## ADDENDUM NO. 04

<b>PROJECT:</b>	<b>Auburn Park Full Build-Out Montgomery County, VA Parks and Recreation</b>
<b>GNI Job No.:</b>	<b>2893.00</b>
<b>DATE:</b>	<b>Friday, March 15, 2024</b>

**2 TYP WALL SECTION - RESTROOM BUILDINGS**  
A103 1" = 1'-0"

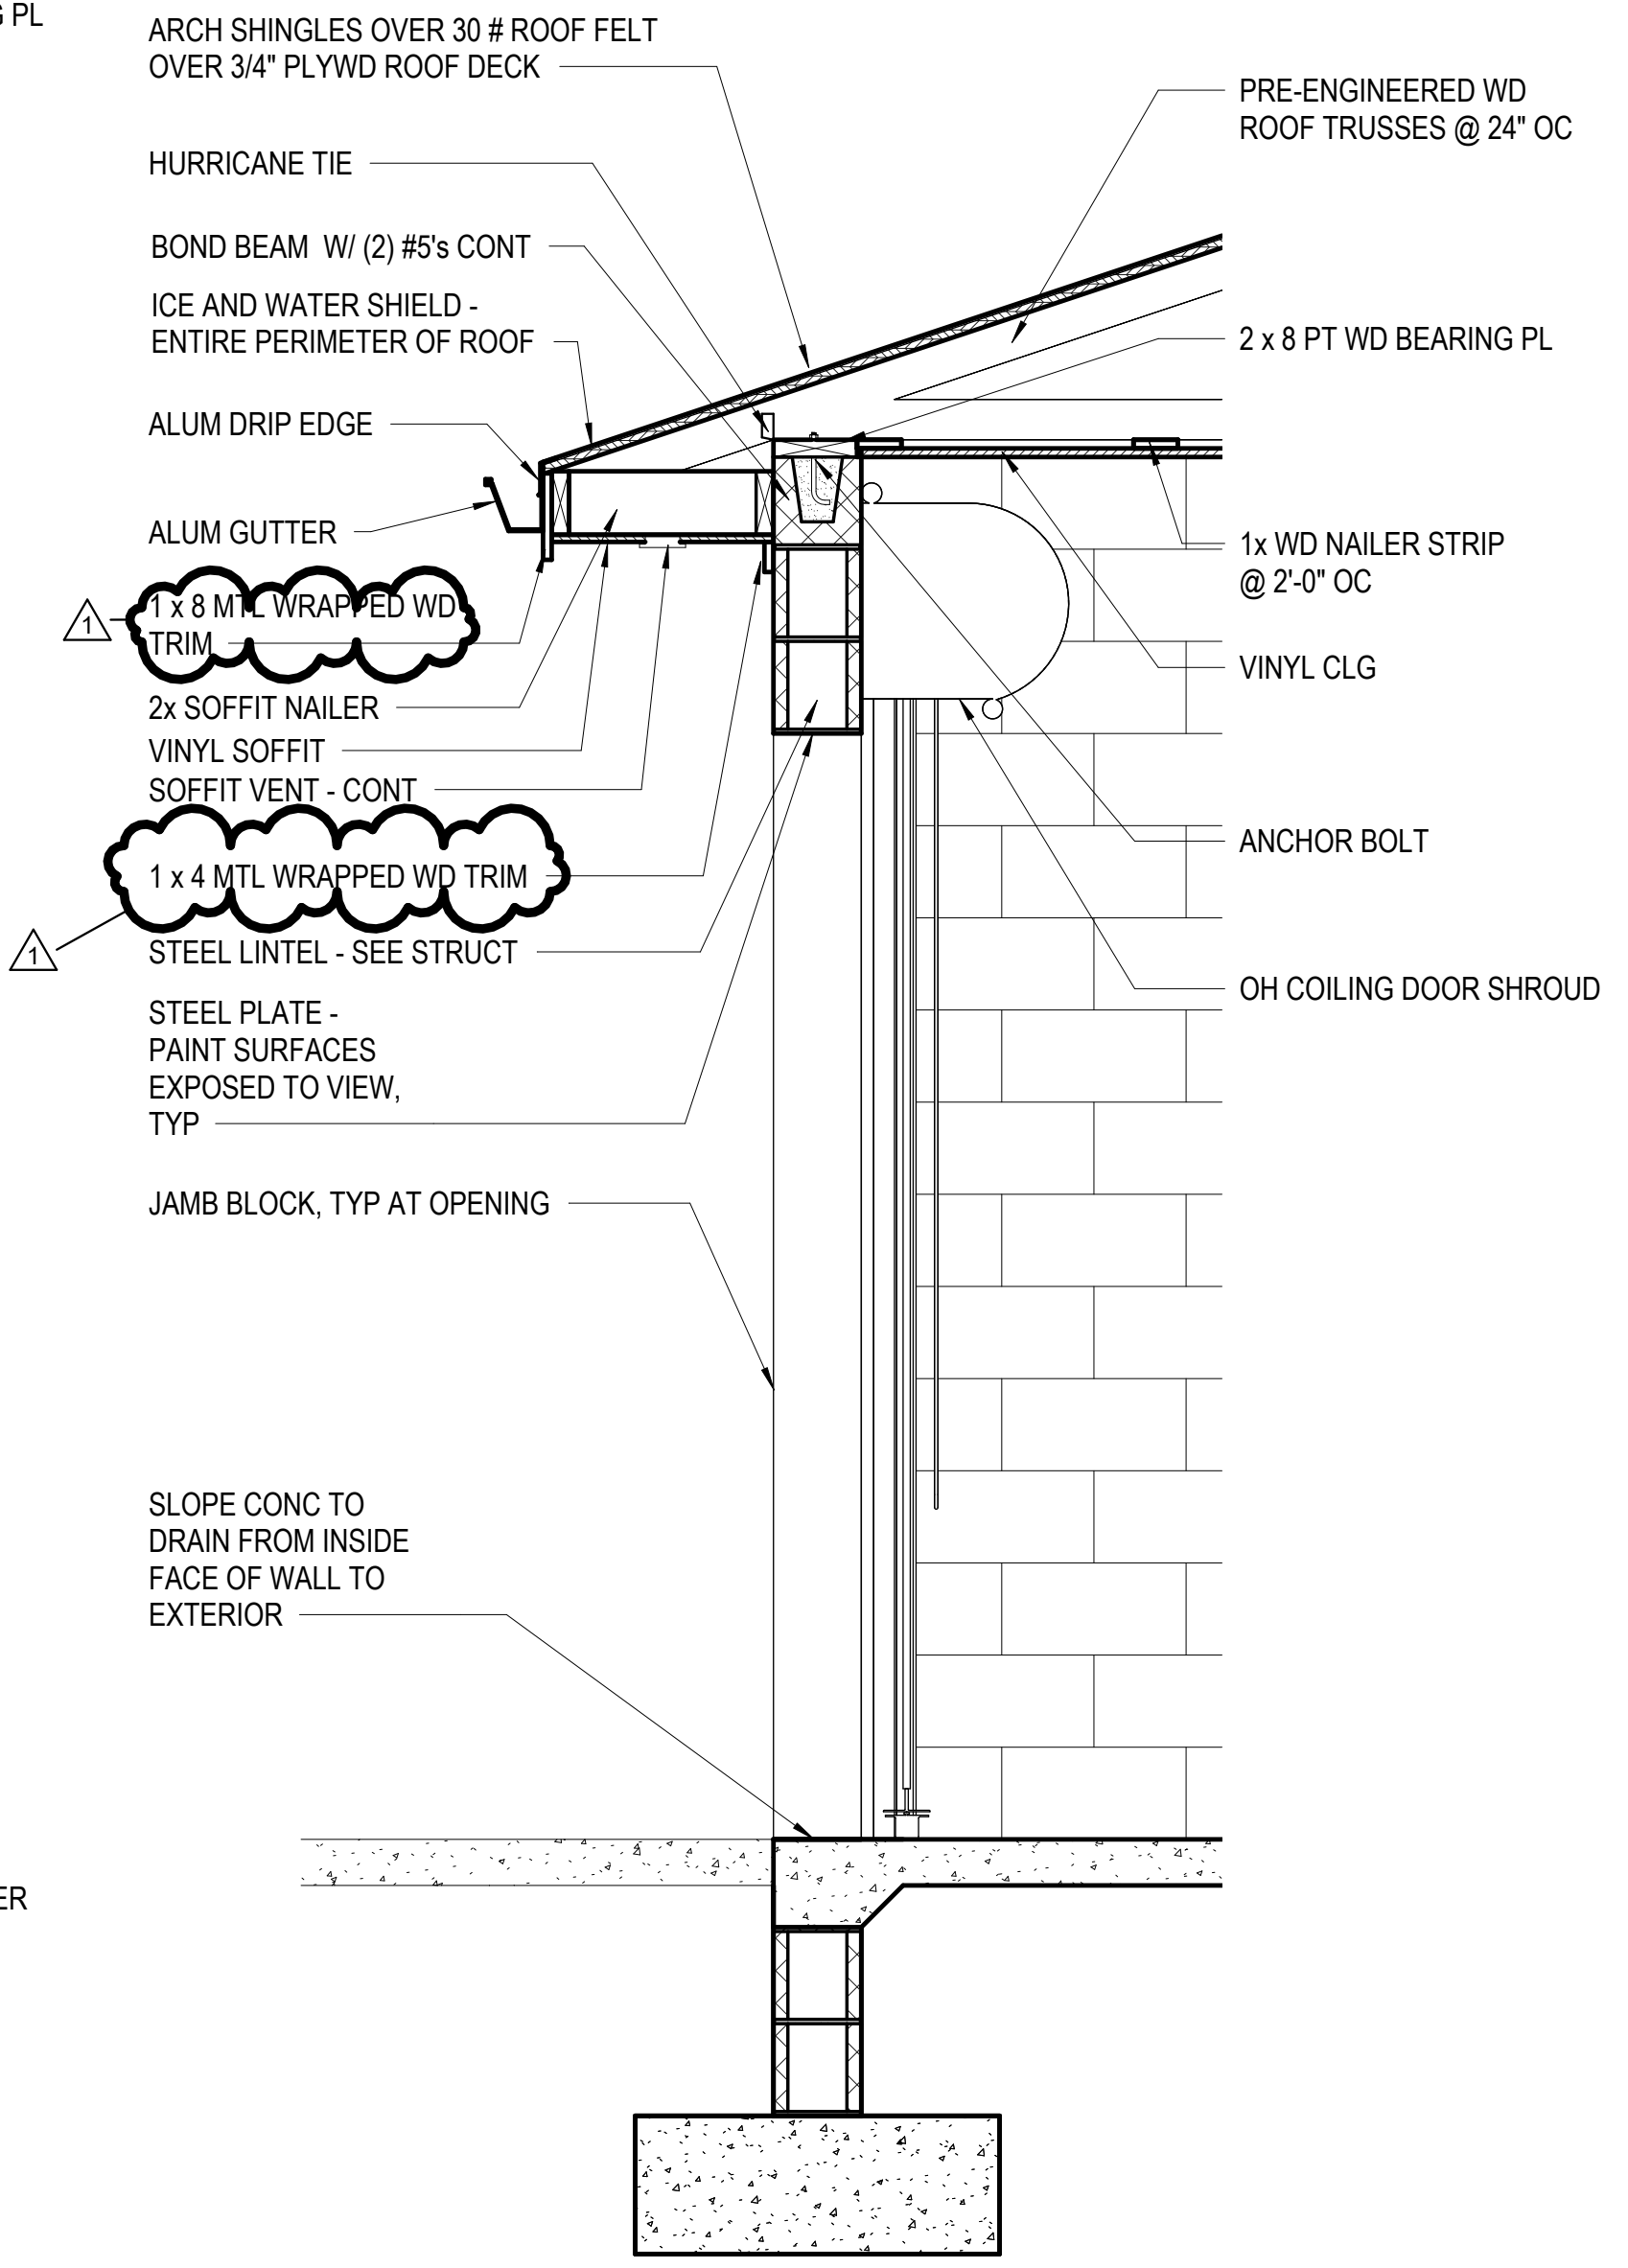
**REVISE** Labels calling for “1 x 8 PVC FASCIA” on all typical wall sections on this sheet to read as follows:

“1 x 8 WD FASCIA – METAL WRAPPED” as shown in attached revised Sheet A104 with revision date 3-14-24.

**REVISE** Labels calling for “PVC TRIM” on all typical wall sections on this sheet to read as follows:  
“1 X 4 MTL WRAPPED WD TRIM” as shown in attached revised Sheet A104 with revision date 3-14-24.

**FLOOR PLAN - DUGOUT**  
1/4" = 1'-0"

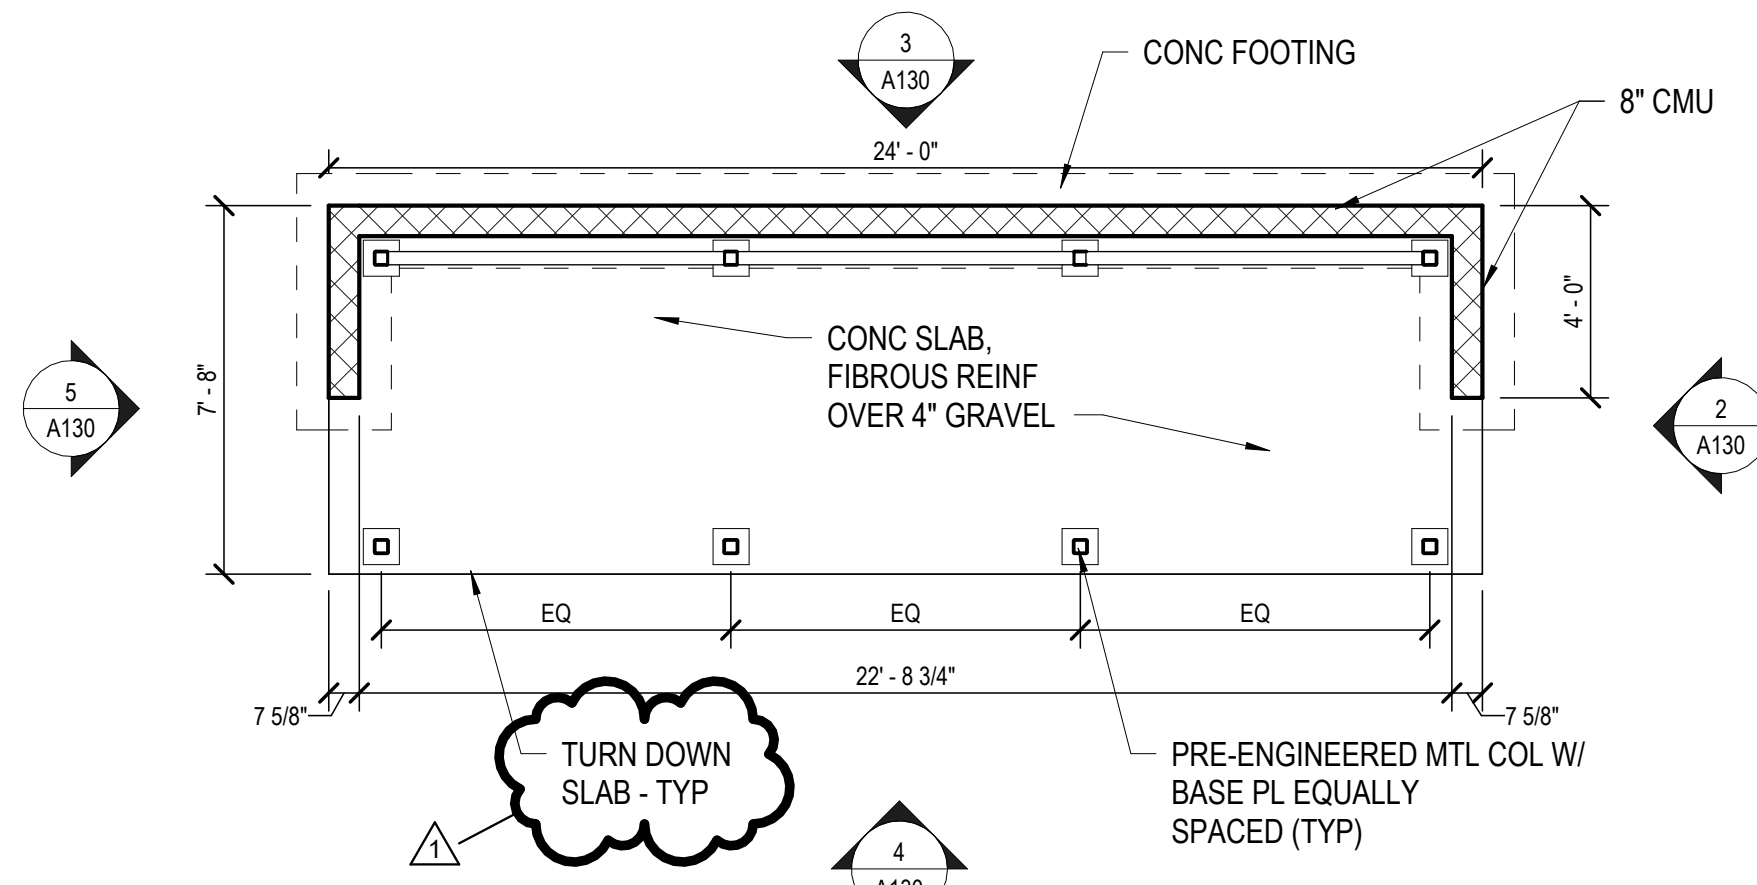
**ADD** label for “TURN DOWN SLAB – TYP” to FLOOR PLAN - DUGOUT as shown in attached revised Sheet A130 with revision date 3-14-24.

**2 ELEVATION - DUGOUT**  
A130 1/4" = 1'-0"

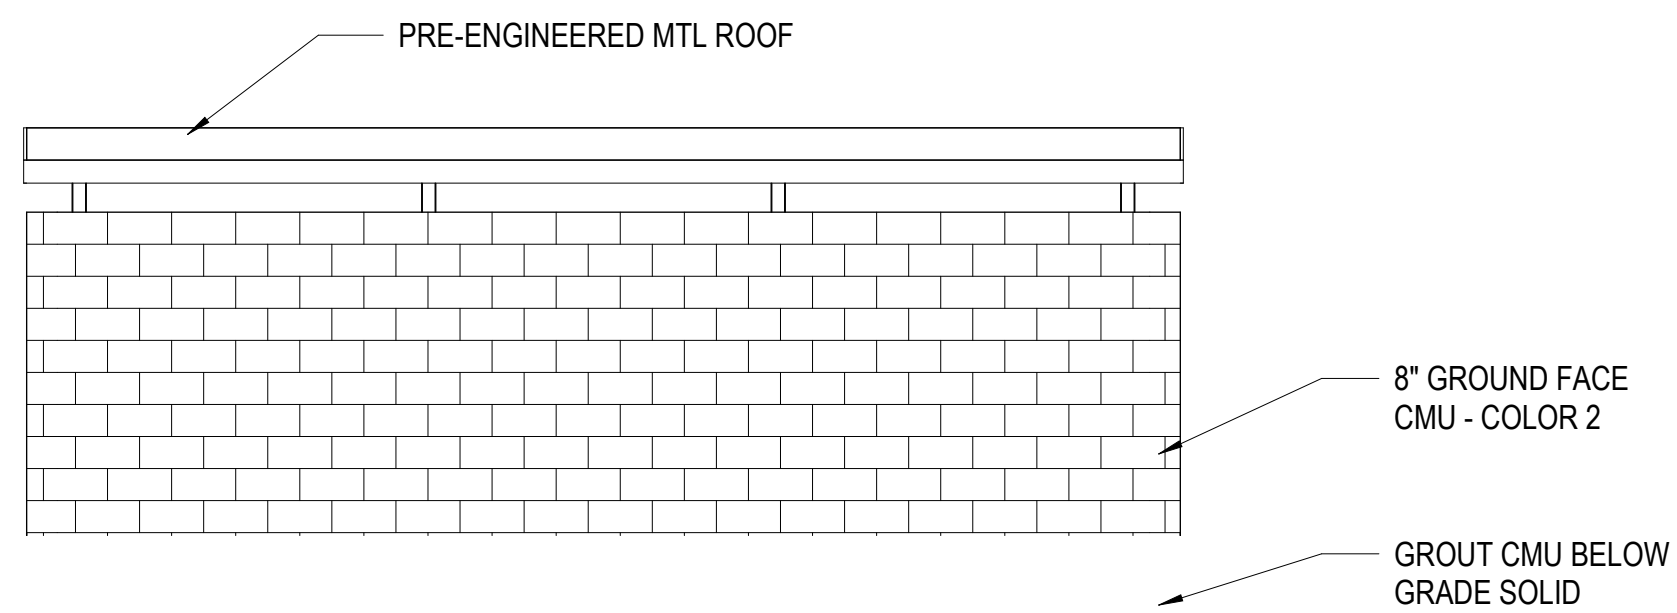
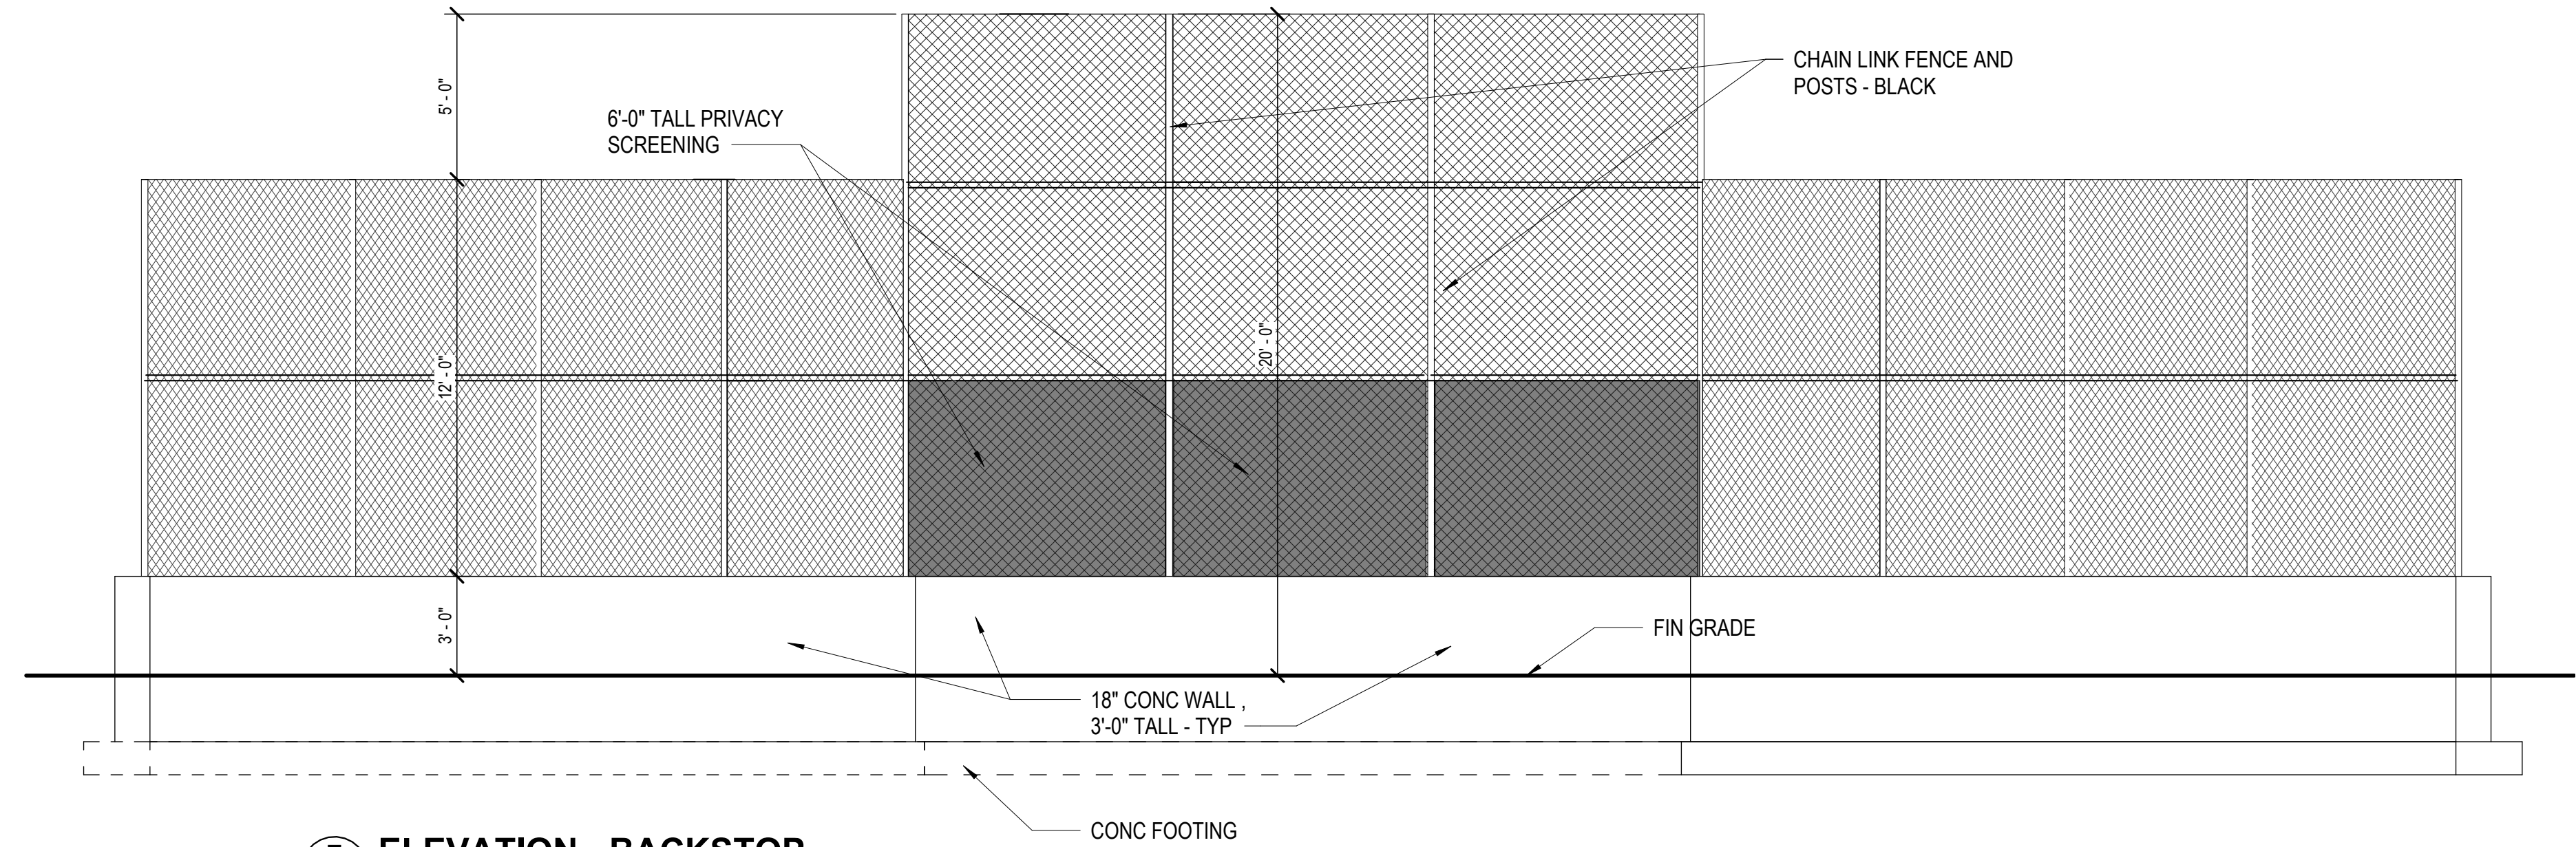
**ADD** “HORIZONTAL STL MEMBERS AT TOP OF BENCH, COORD HEIGHT W/ HEIGHT OF BENCHES” to ELEVATION- DUGOUT as shown in attached revised Sheet A130 with revision date 3-14-24.

**2 ELEVATION - SIGN**  
A140 1/4" = 1'-0"

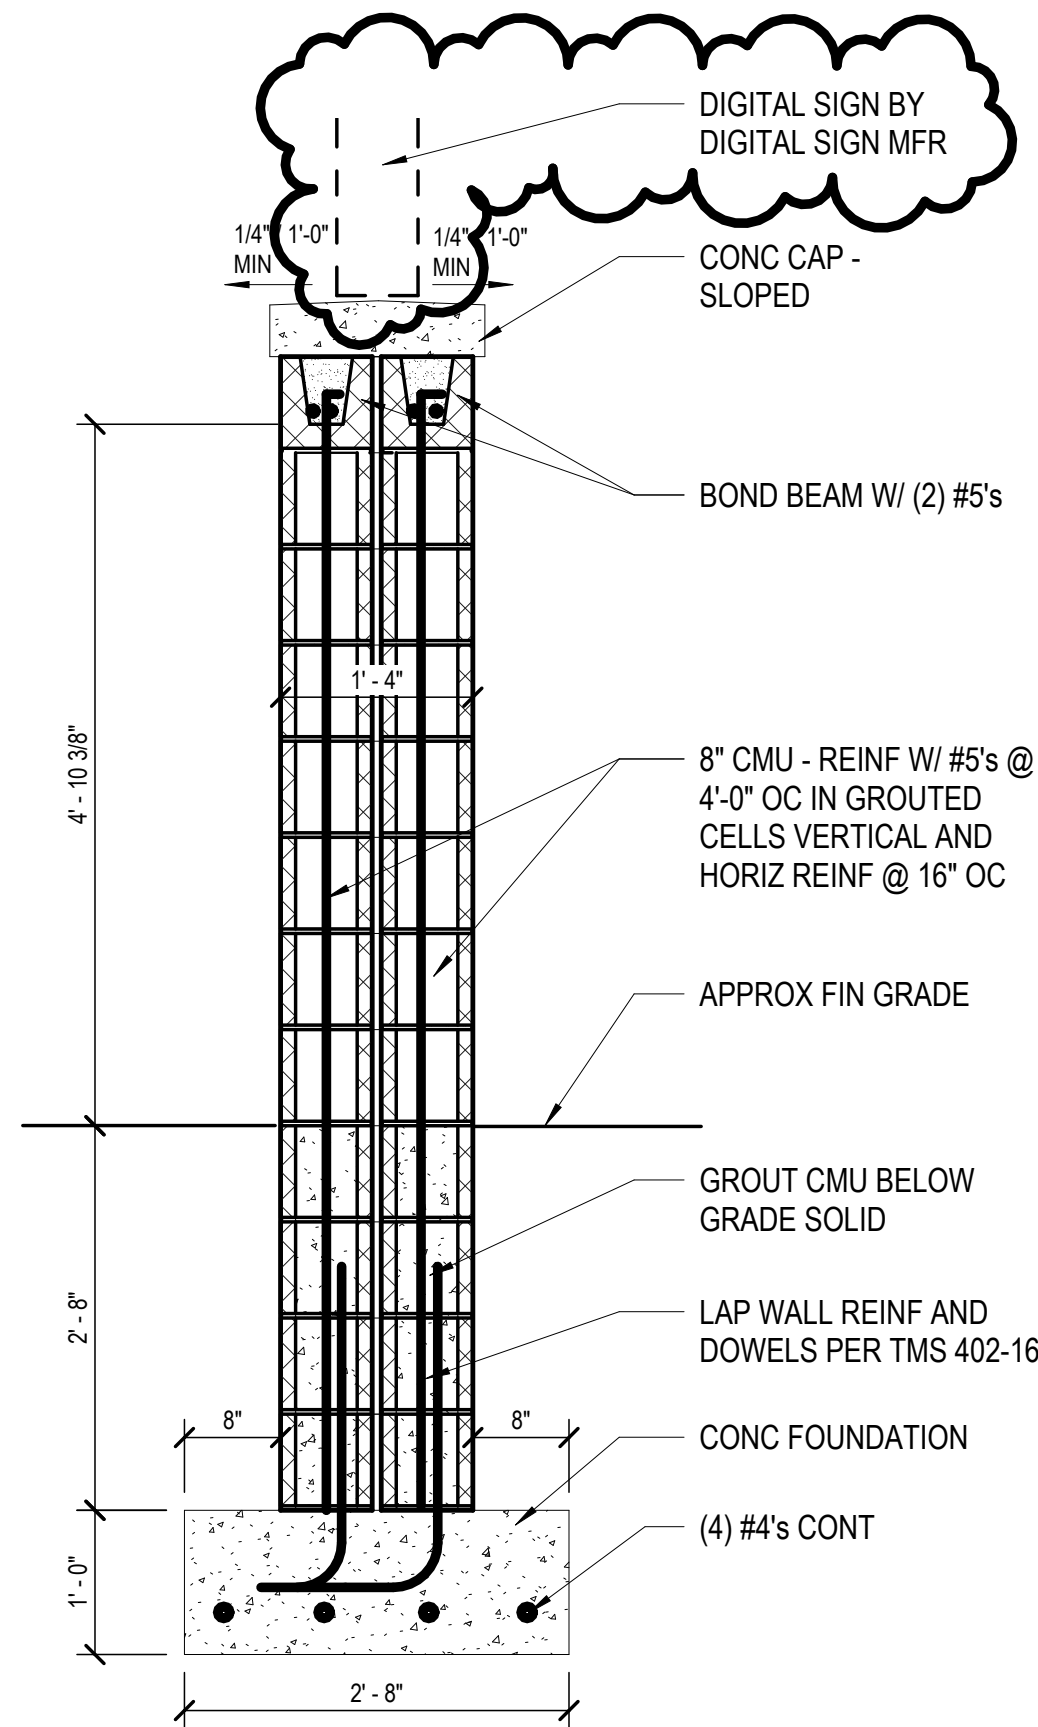
**ADD** DIGITAL SIGN BY DIGITAL SIGN MFR to ELEVATION – SIGN detail as shown in attached revised Sheet A140 with revision date 3-14-24.

**ADD** DIGITAL SIGN NOTES as shown in attached revised Sheet A140 with revision date 3-14-24.
